11/15/06 Bd Mtg
Shasta River
Deadline: 11/1/06 12 pm

Please find the attached detailed comments of the first public draft staff report of the Shasta River TMDL (and also Table 4 of the Basin Plan amendment language) from the Quartz Valley Indian Reservation's Environmental Protection Department.

MEMORANDUM REPORT

Figure 1. Shasta River Chinook salmon returns from 1930 to 2005 are displayed in this chart along with known Pacific Decadal Oscillation cycles (Hare et al., 1999).

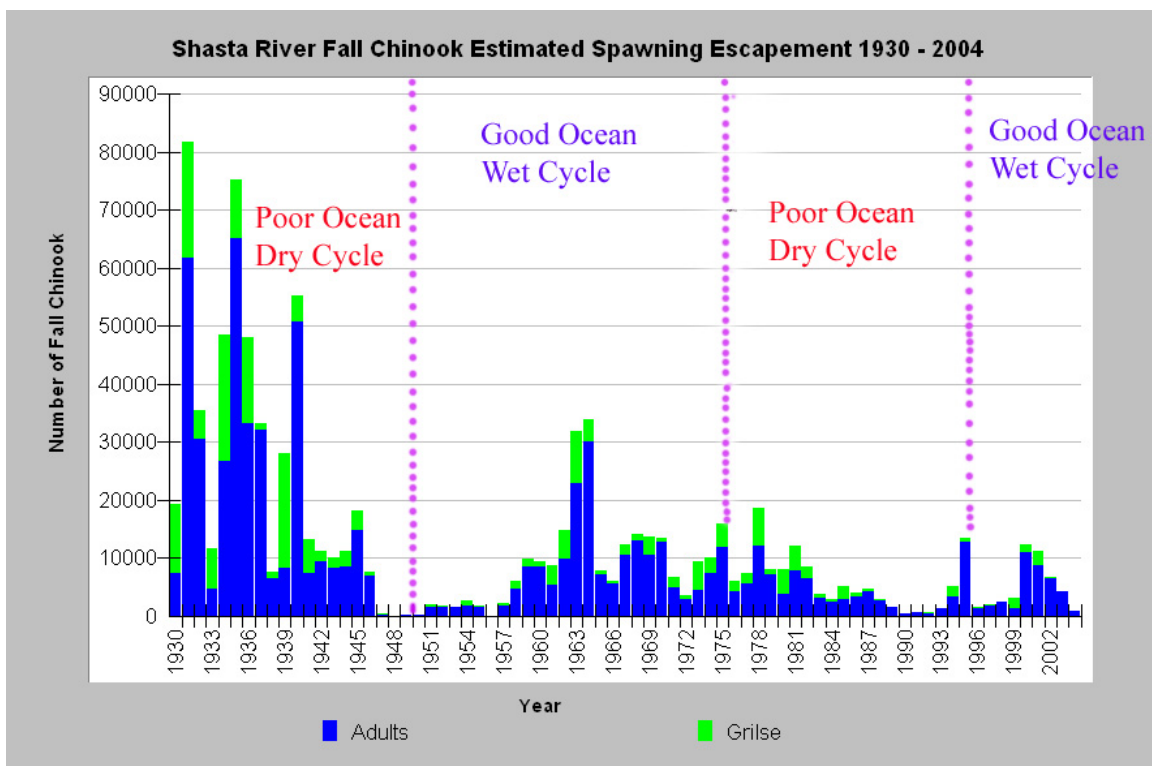
The Chinook salmon population of the Shasta River is showing a long term decline (Figure 1) that does not bode well for long term survival. The population is failing to rebound despite recent average and above average rainfall years and mostly favorable ocean conditions. Collison et al. (2003) point out that PDO conditions will switch back to negative ocean and dry on land sometime between 2015 and 2025 and that, if freshwater habitat conditions have not improved by that time, stock losses are likely to occur. Shasta stocks ranged from 533-726 from 1990-1992 during the last dry climatic cycle, a critically low level (Gilpin and Soule, 1990). The final Shasta TMDL should cite the findings of Hare et al. (1999) and use it as a reason for urgency of to move forward on a TMDL Implementation Plan.

Figure 2. Increased flows with the end of stock water season decreased water temperature and triggered increased fall Chinook salmon migration into the Shasta River.

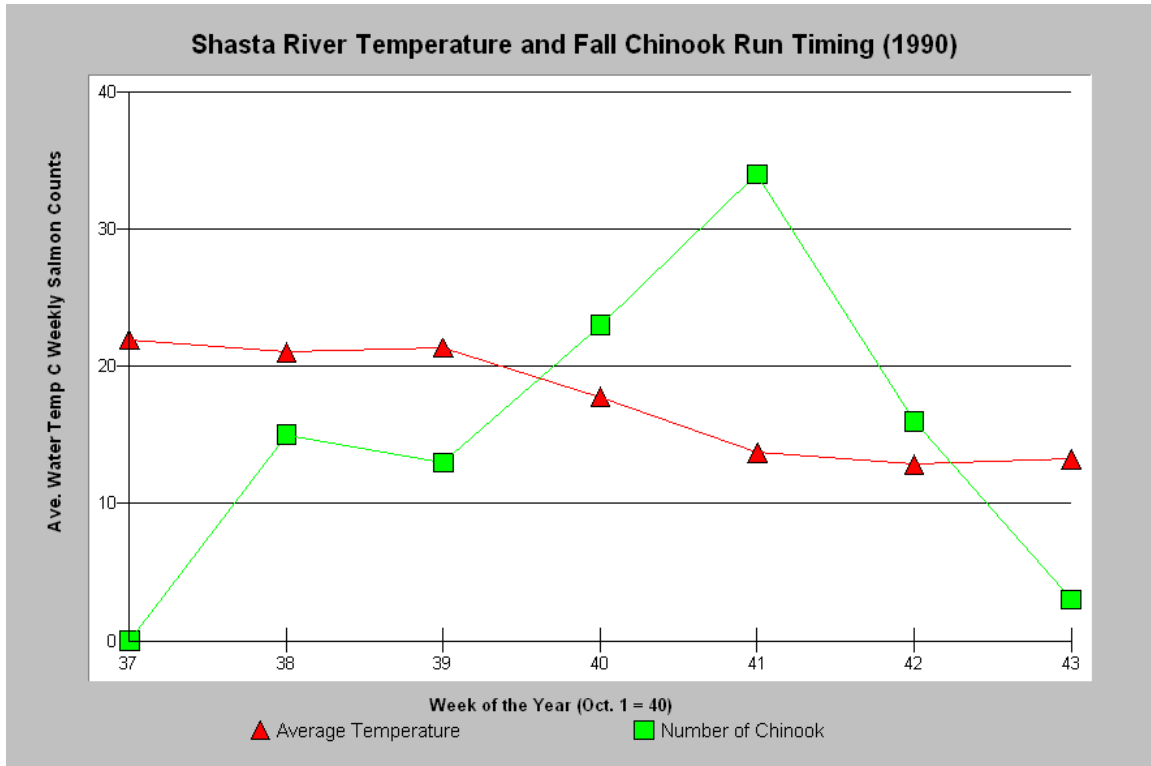
The Shasta TMDL does not address the October 1 deadline for shutting off stock water and increasing stream flows for fish passage. Snyder (1931) noted that fall Chinook salmon entered the Shasta River in September. Fish now delay their migration until after October 1 because of lack of sufficient flow and associated warm water temperatures (Figure 2). This delayed pattern of entry into the Shasta River is manifest in both wet and dry years (Figure 3). Fall chinook forced to sit for weeks in stressful Klamath River conditions likely have reduced fecundity. This intensive selection pressure likely selects for later run timing. For

Figure 3. Fall chinook in 1994 and 1995 waited until the first week in October to move into the Shasta River because of increased flows at the end of the stock water season.

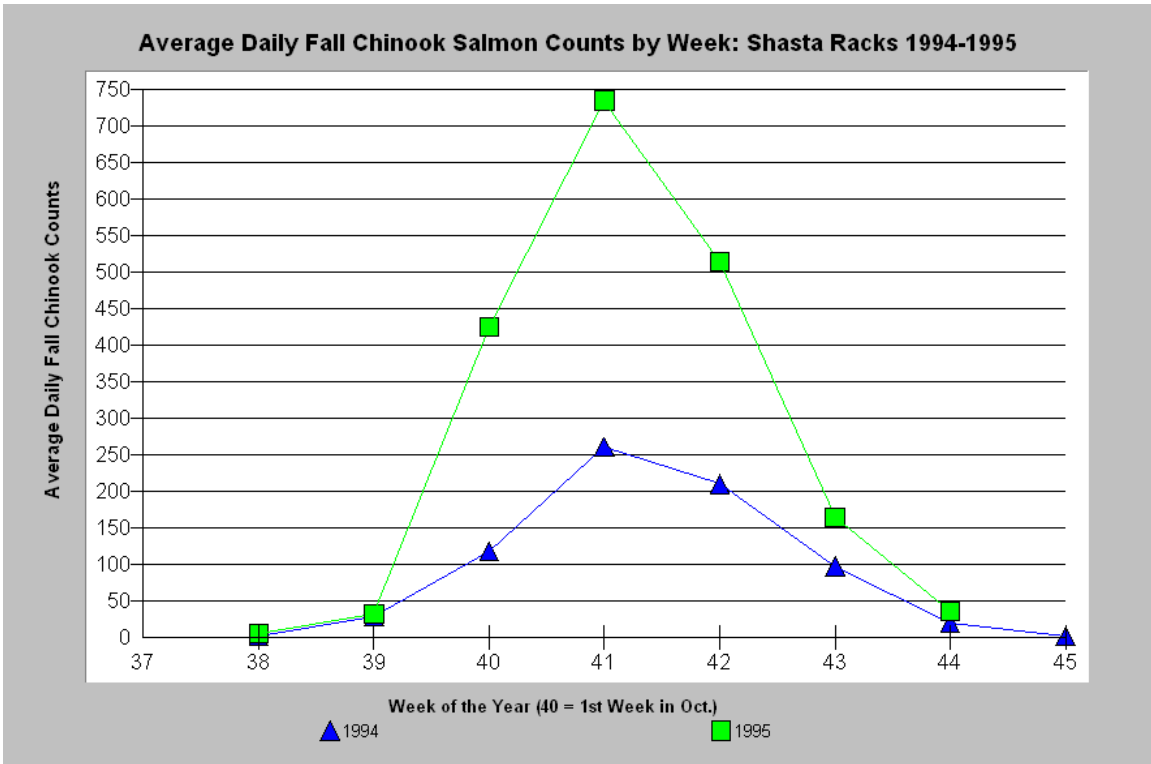
The fish distribution map indicates that Big Springs is not currently salmonid habitat yet the California Department of Water Resources (1981) *Klamath and Shasta River Spawning Gravel Enhancement Study* showed a huge concentration of fall chinook spawning Big Springs Creek. This is a tangible indication that Big Springs Creek was a major refugia for Pacific salmon in the early 1980's before reduction of flows due to ground water pumping. Figure 4 shows riparian destruction in lower Big Springs Creek and the adjacent reaches of the Shasta River that would also degrade fish habitat and lead to thermal pollution (Kier Associates, 1999).

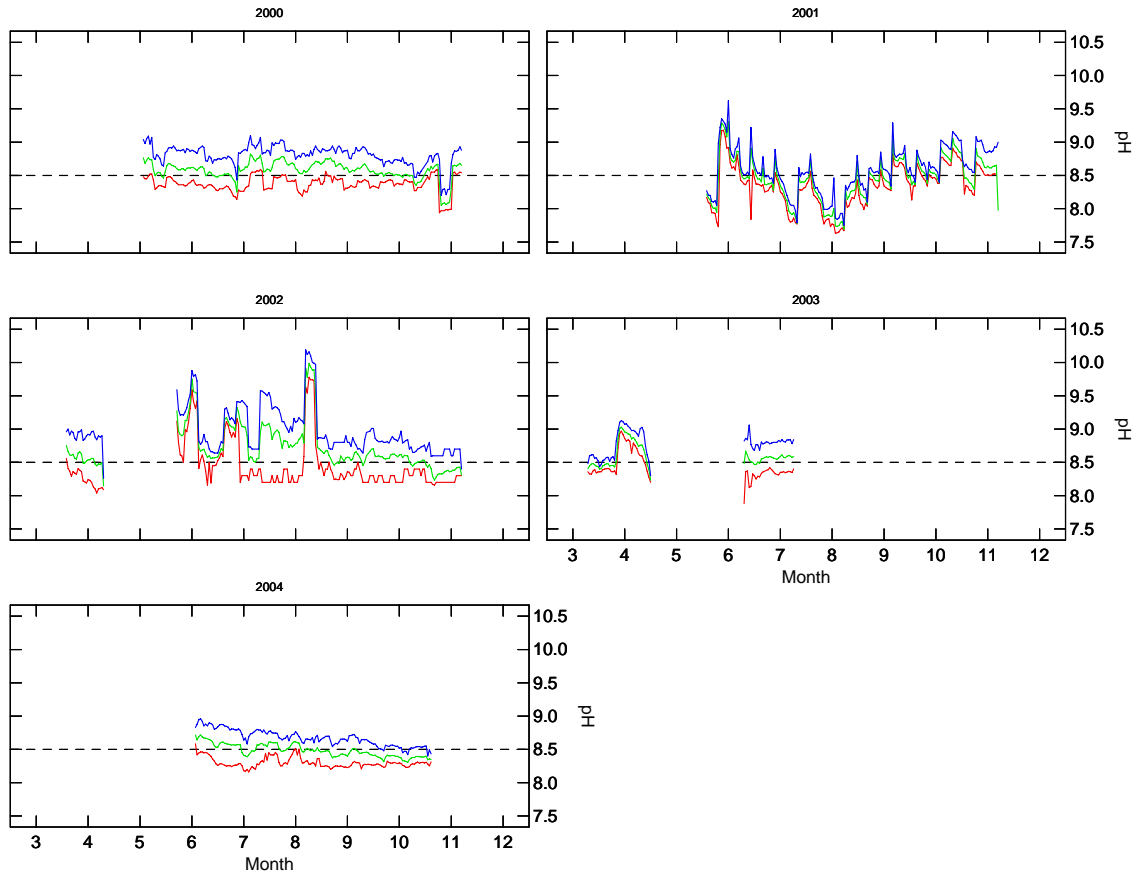
The mouth of the Shasta River has been monitored with automated water quality probes since 2000. Data from 2000-2004 show that maximum pH typically exceeds the *Basin Plan* objective of 8.5 for most days from June through September (Figure 5). TMDL Appendices A and C contains continuous pH data from other sites in the Shasta River. Goldman and Horne (1983) note that at pH of over 9.5 that all ammonium ions would be converted to dissolved ammonia, which is highly toxic to salmonids. These pulses of extreme pH occurred in seasons of downstream juvenile migration (June 2002) and during periods when adult Chinook salmon may be holding (September 2001) downstream of the mouth of the Shasta in the Klamath River.

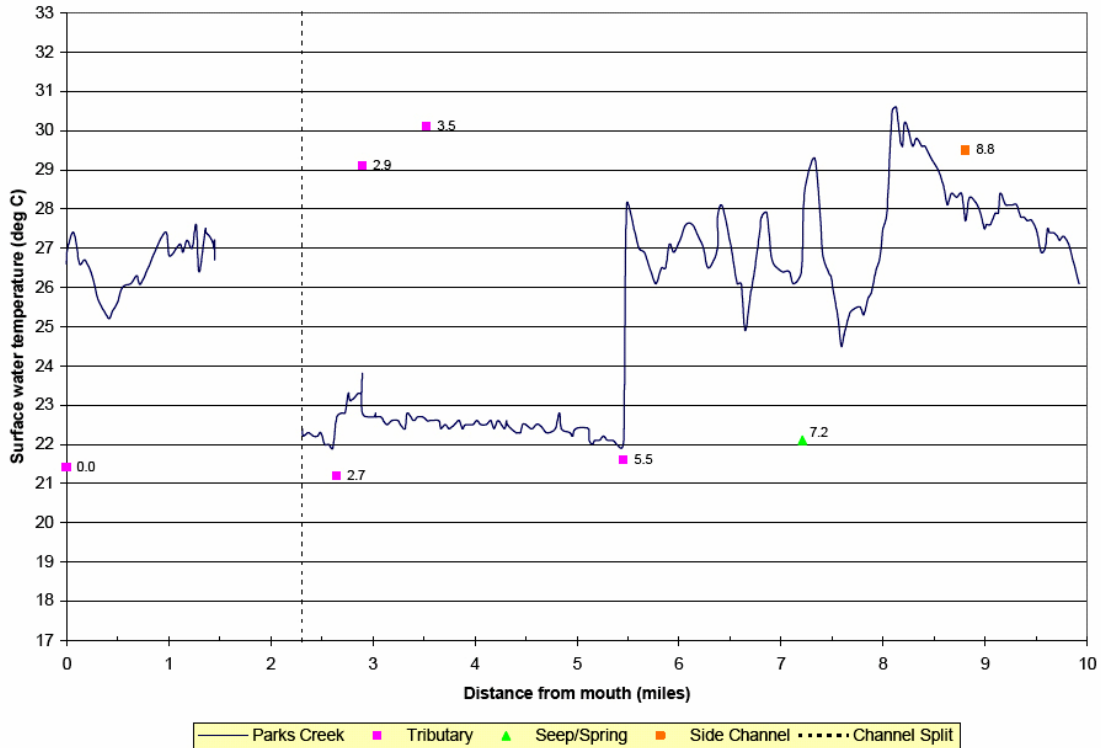
The Shasta TMDL does not present the thermal evidence (Watershed Sciences 2004) that flow depletion is causing stream warming in tributaries Parks Creek and the Little Shasta River. Data and TIR images show temperature oscillations in Parks Creek and the Little Shasta River that indicate these streams warm as their flows are depleted (Figure 6). Kier Associates (2005b) described a similar effect on Shackleford Creek in the Scott River. Diversion also completely dries up reaches that would otherwise be suitable habitat for salmonids (Figure 7). Changing patterns of diversion on lower Parks Creek would provide a cold water reach connected to the mainstem Shasta River that could serve as a refugia for juvenile salmonids.
